Subdivision and Land Development Cover  
Page for SLD # 07-25

Project Name: Quaker Park Redevelopment

Status: UNDER REVIEW

**RE: Sketch Plan Review**  
**1001 E. Hector Street**  
**Whitemarsh Township, Montgomery County, PA**  
**S/LD # 07-25**  
**Our Project Number 2025-01046**

Drawing No.: **SK-01**

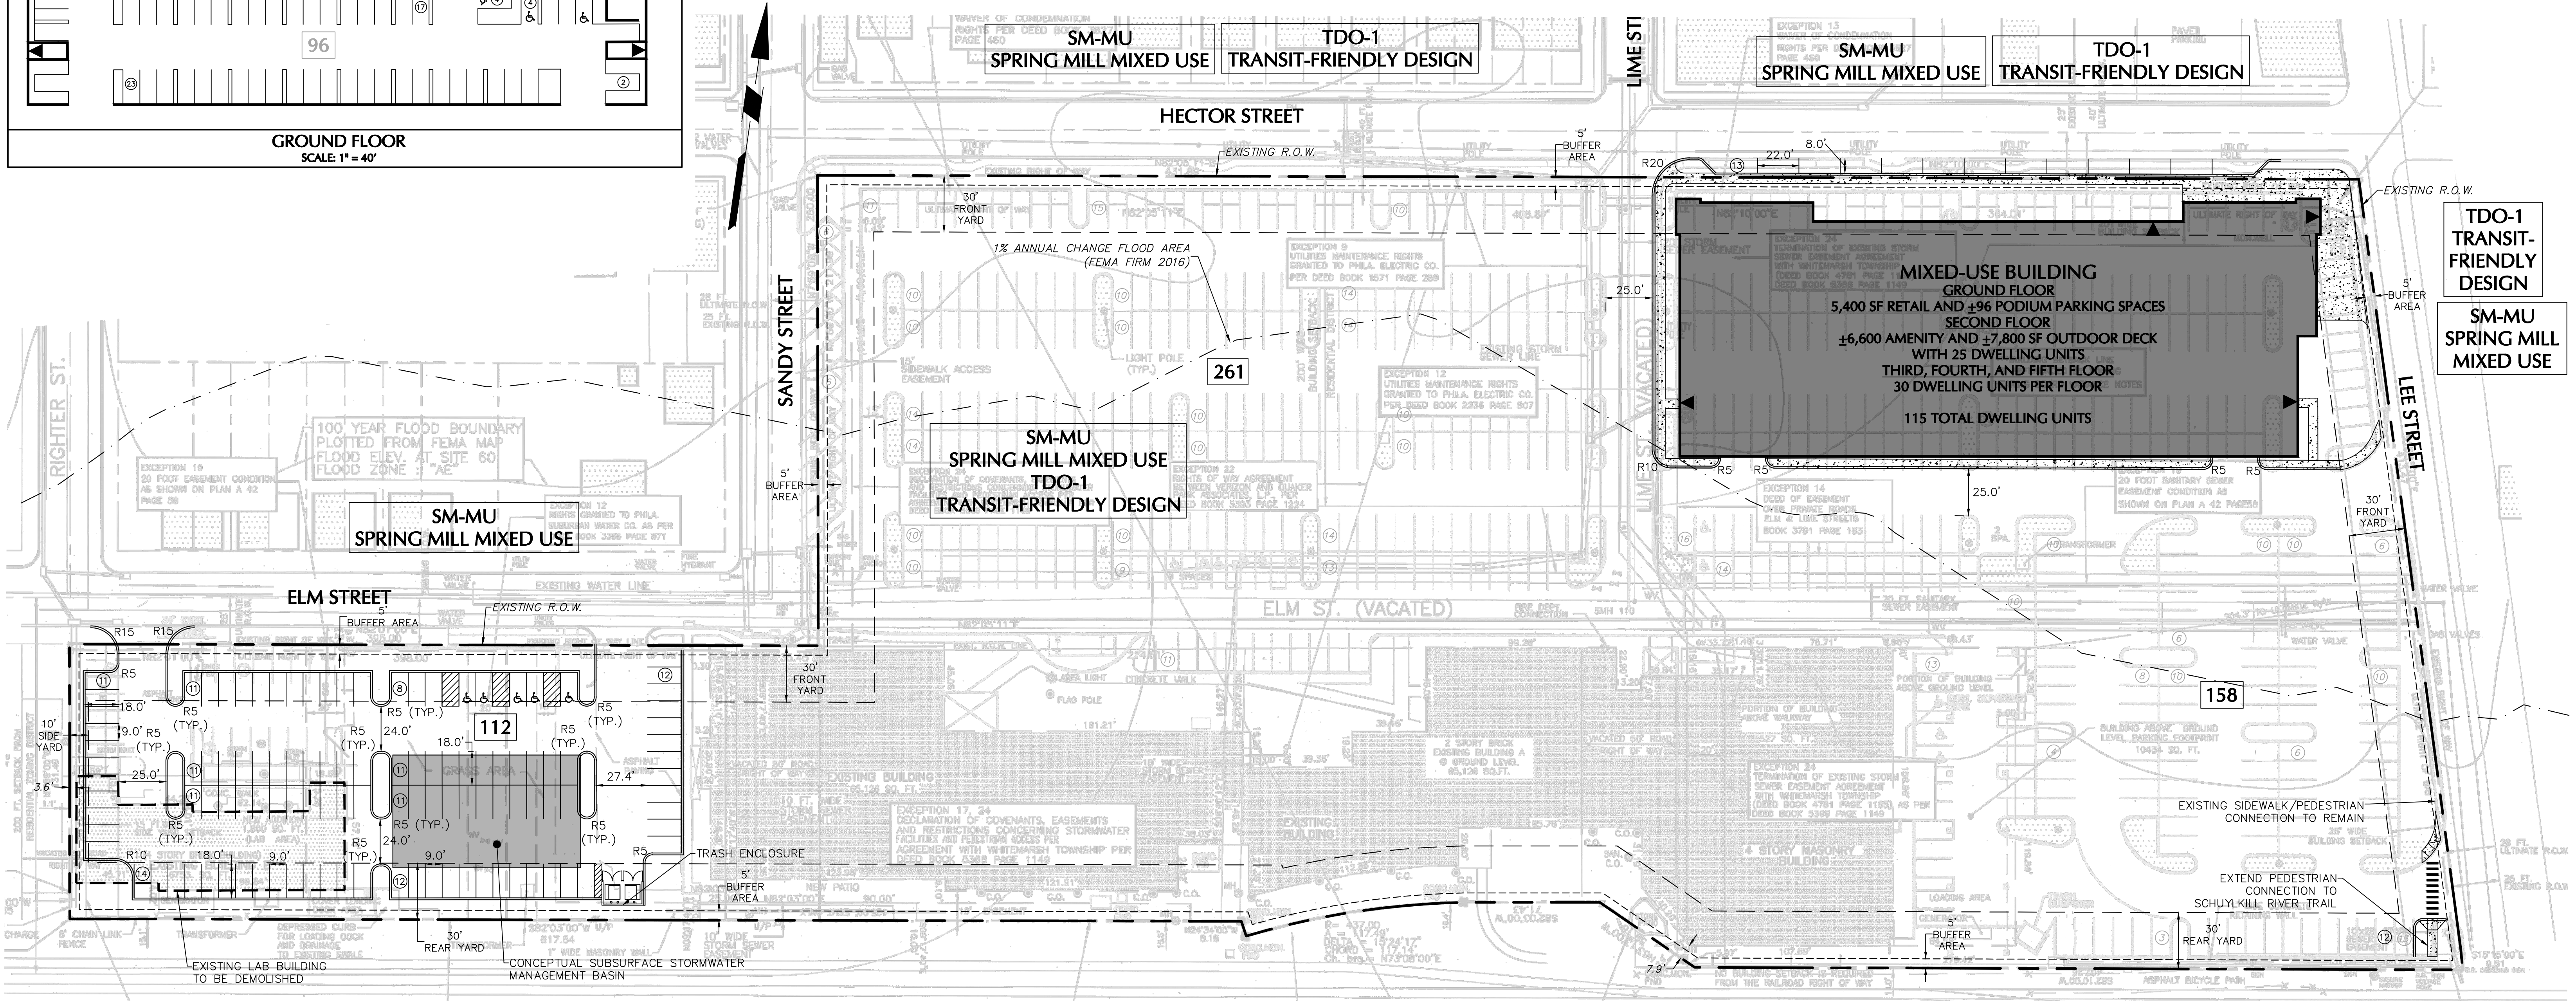
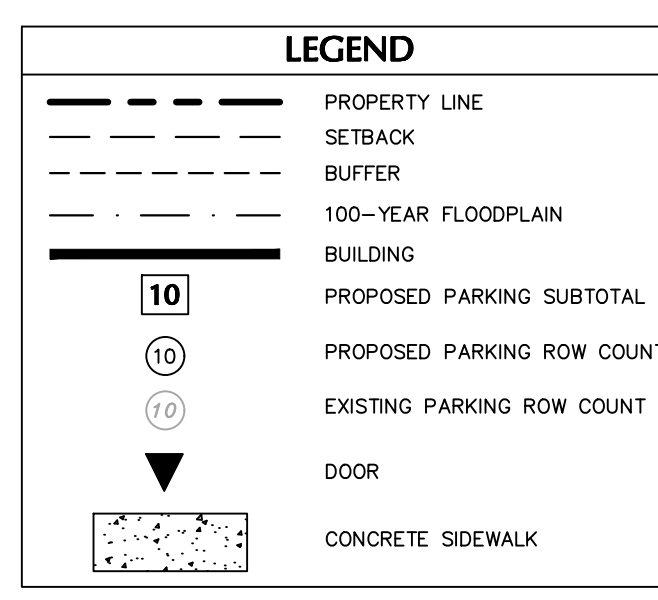
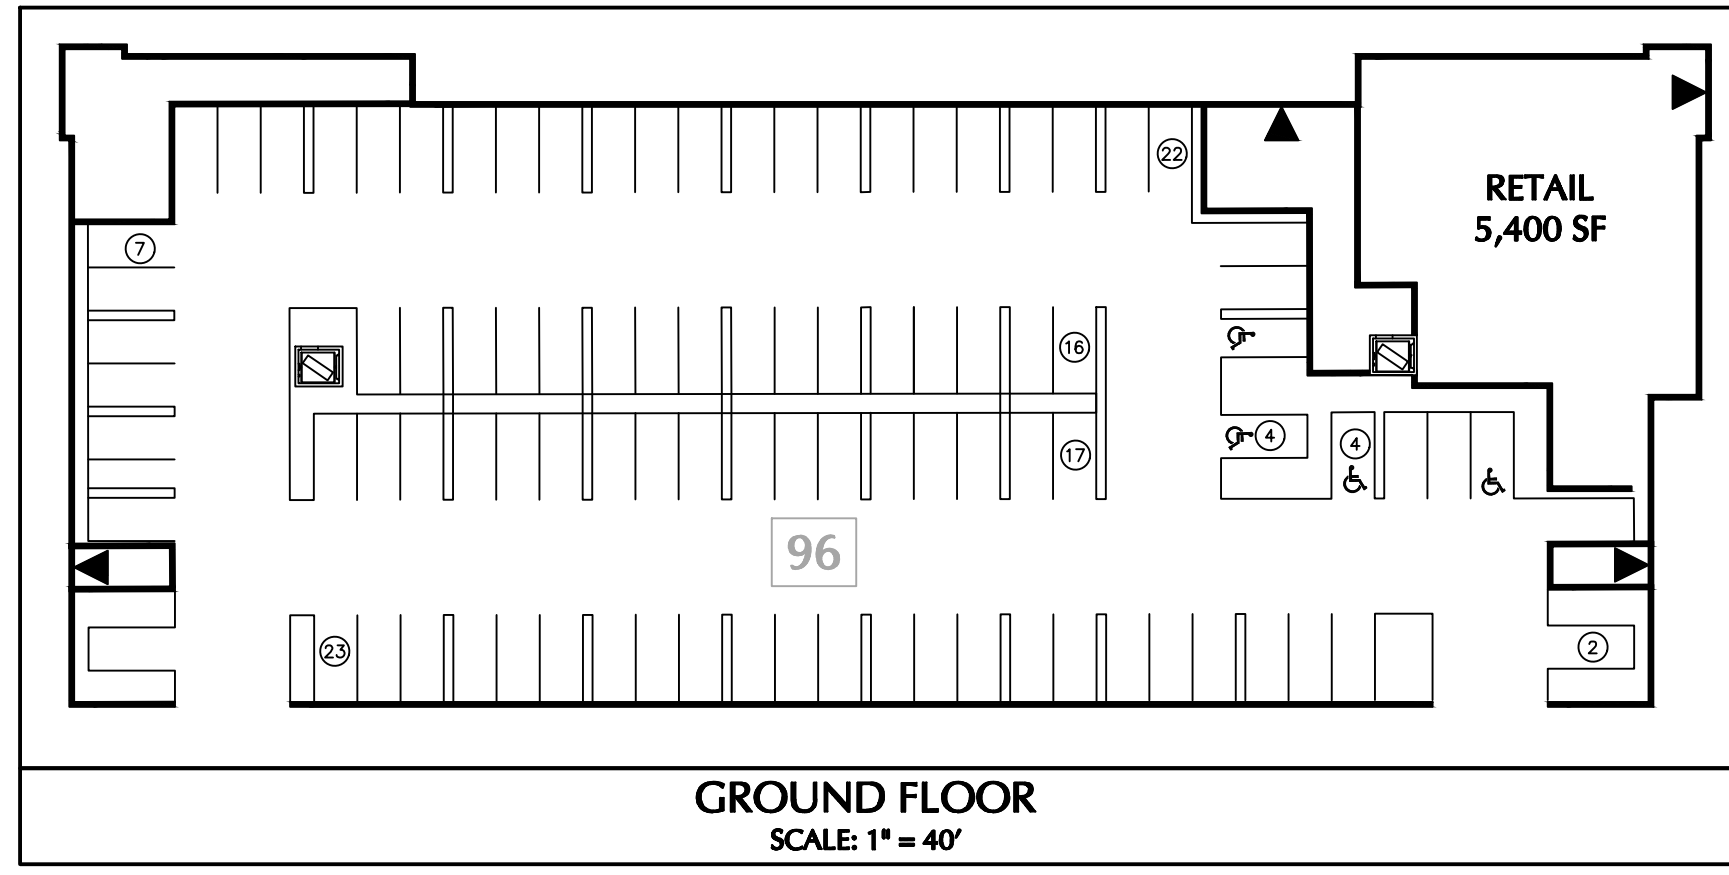
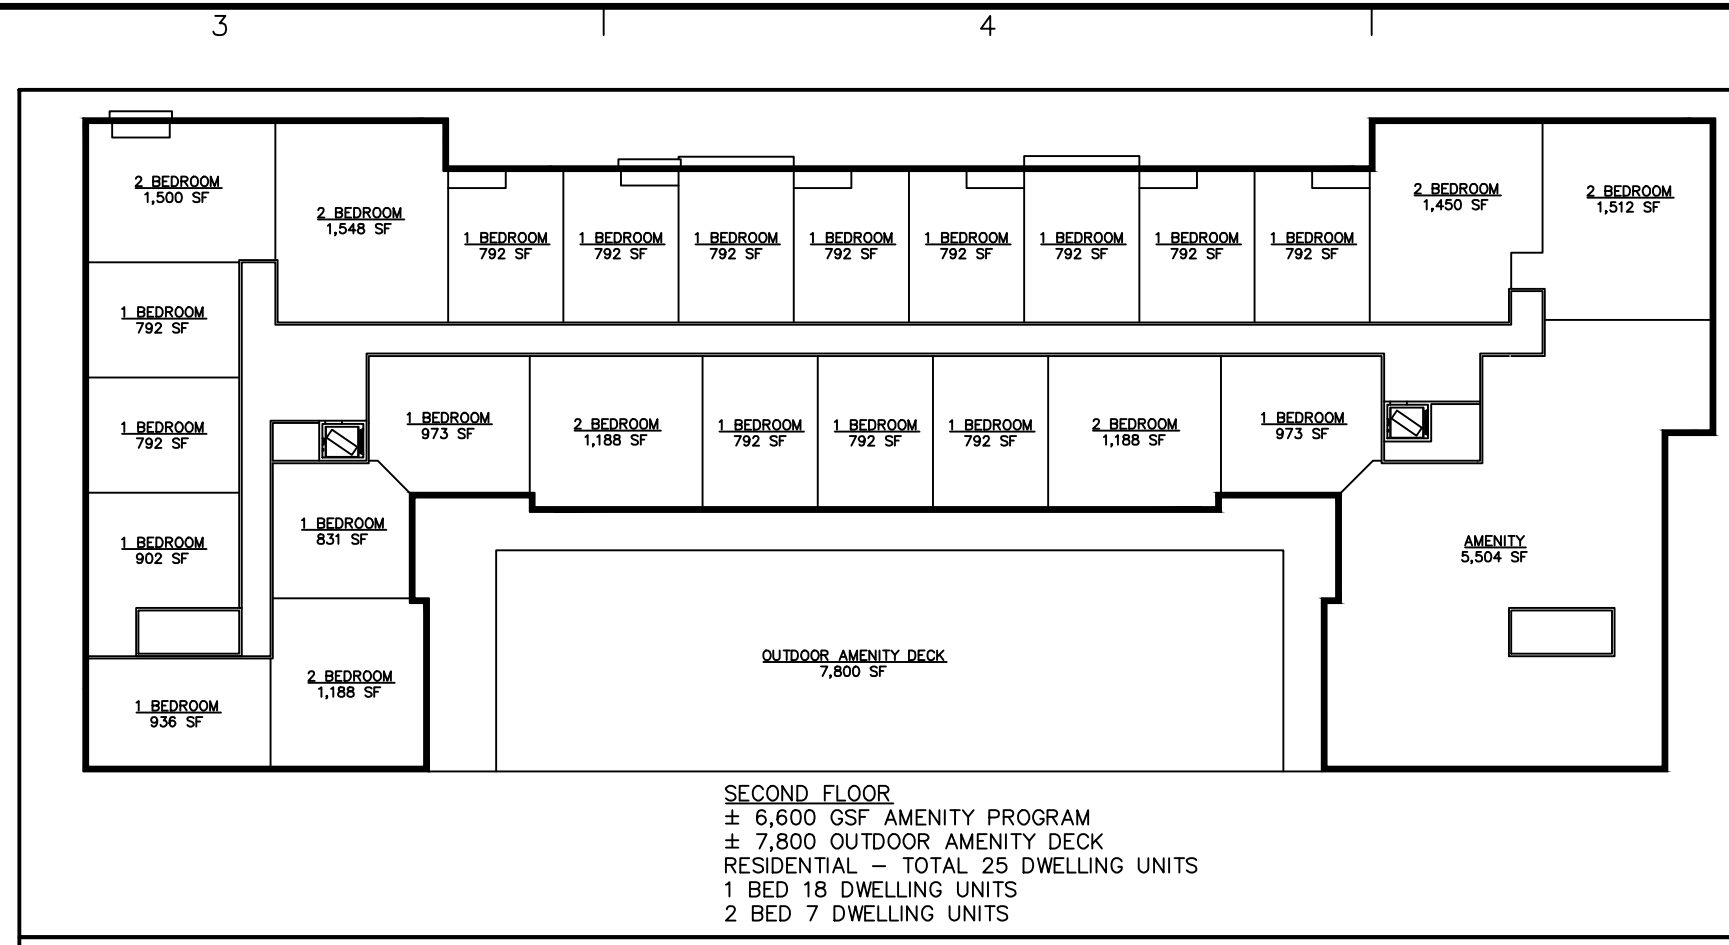
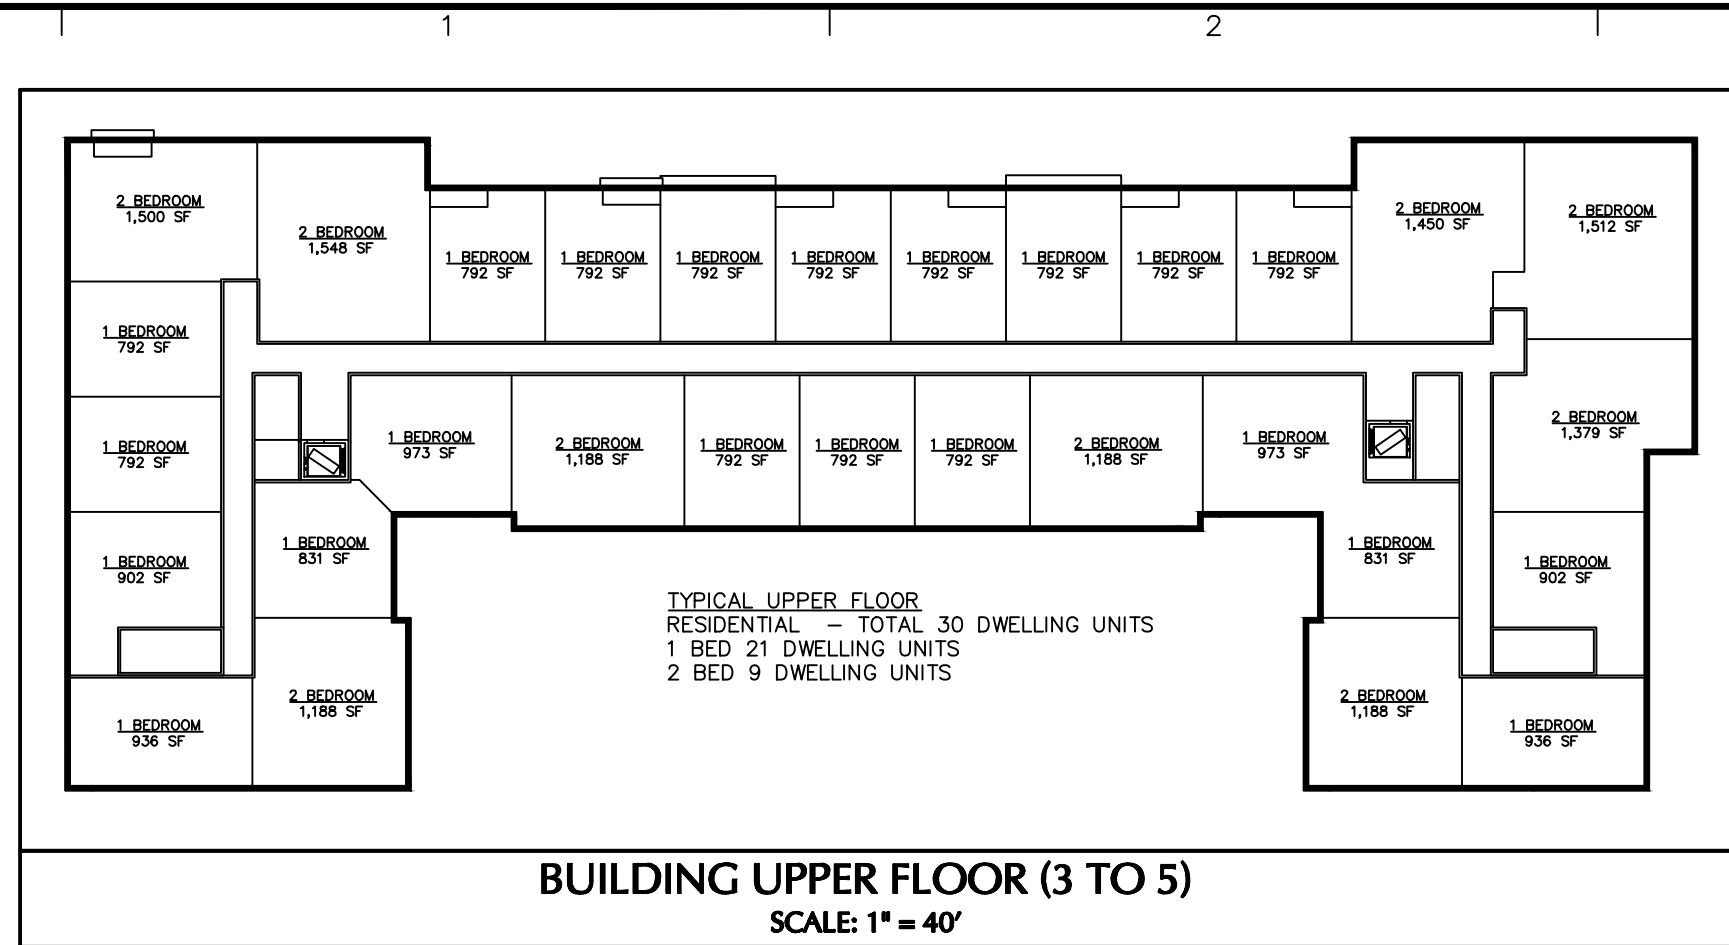
<u>Section</u>	<u>Description</u>
1. 105-20(A)(4)(a)	The plans must be revised to show Zoning District boundaries, and the Transit-Friendly Design Overlay (TDO-2) District must be labeled.

23. 105-30 The plans must be revised so that no portion of the proposed building would be located within the required Ultimate Right-of-Way of E. Hector Street.

24. 105-30(A) The plans must be revised to include dimensions for the cartway, and Legal and Ultimate Right-of-Way lines for adjacent streets.
25. 105-35(C) No structure, fence, planting or other structure shall be maintained between a plane two feet above the curb level and a plane seven feet above curb level so as to interfere with traffic visibility across the corner with that part of the required front yard which is within the clear sight triangle. Sight triangles must be shown on the drawings. As defined by Section 105-5, clear sight triangles shall include the area bounded by any two intersecting street lines and a straight line drawn between points on each such line 50 feet from the intersection of said lines or extensions thereof. A portion of the proposed building appears to be located within the required clear site triangle.

35. 105-38(O)	Parking areas shall be located at least 10 feet from any building or structure. The plans currently show parking spaces within 10 feet from a structure, which must be revised in order to demonstrate compliance with the requirements of this section of the ordinance.

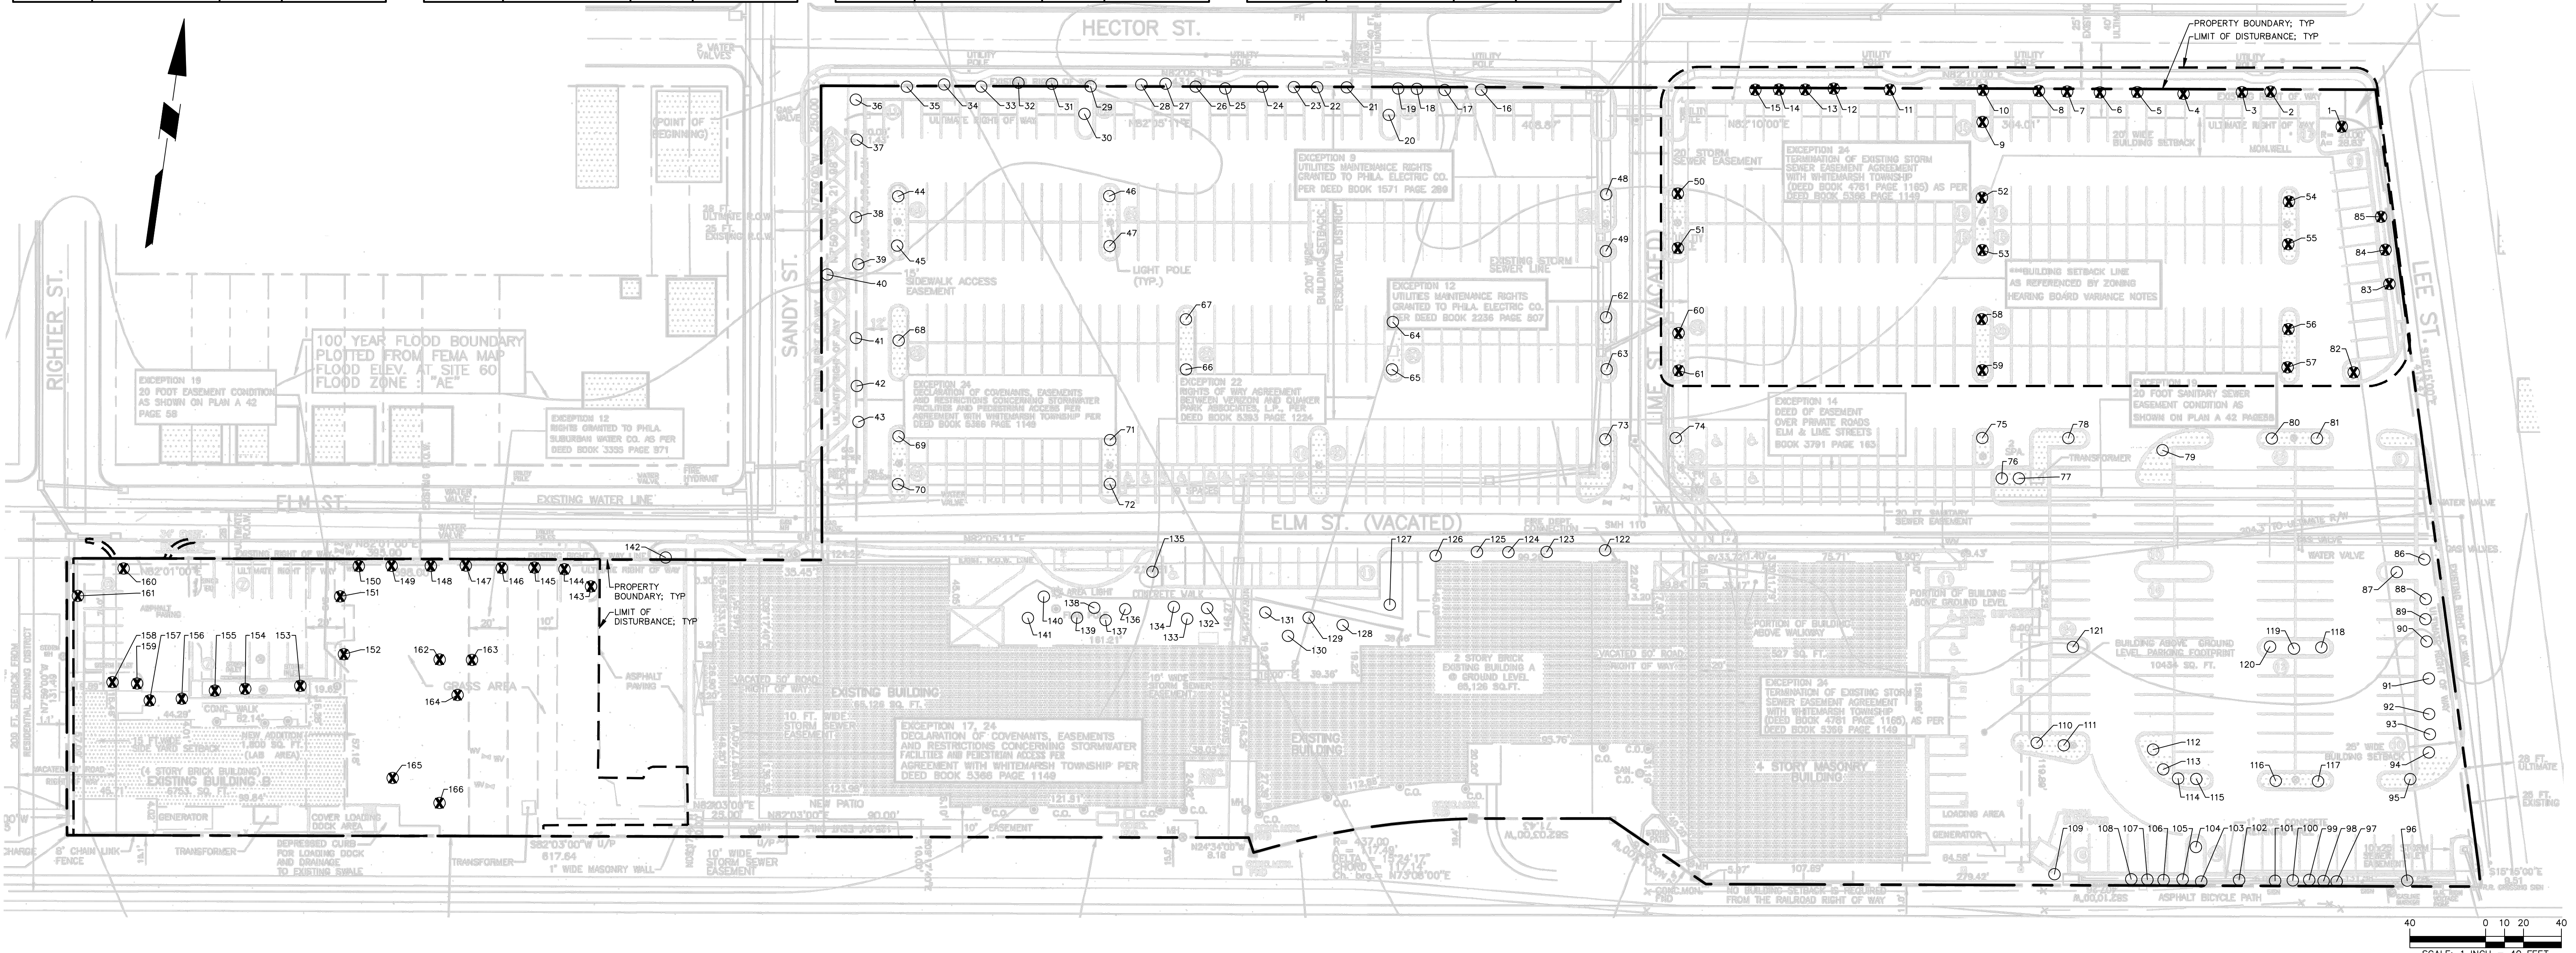
**No tree protection is provided. Plans shall be updated to show tree protection and the tree protection detail.**
